- Subject** ▶ Change of Gear Housing and Gear Housing Cover, and Addition of Felt and Seal plate.
- For Models** ▶ 4304, 4305, 4306, 4304T and 4305T (Jig Saws).
- Description** ▶ As illustrated below, several parts have been changed for improvement of protection from dust.

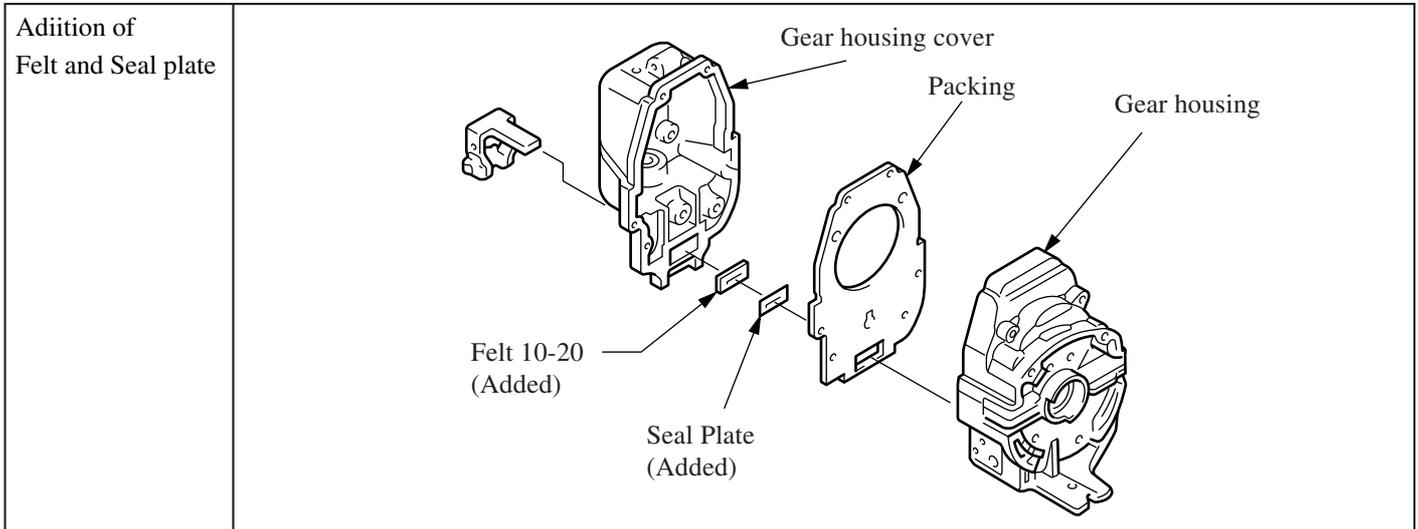
▶ Current	▶ New
Change of Gear Housing		<p>Shape has been changed.</p>
Change of Gear Housing Cover		
Change of Balance Plate (4304T, 4305T)		<p>Common to 4304/4305</p>
Change of Packing		<p>Smaller hole than the current</p>
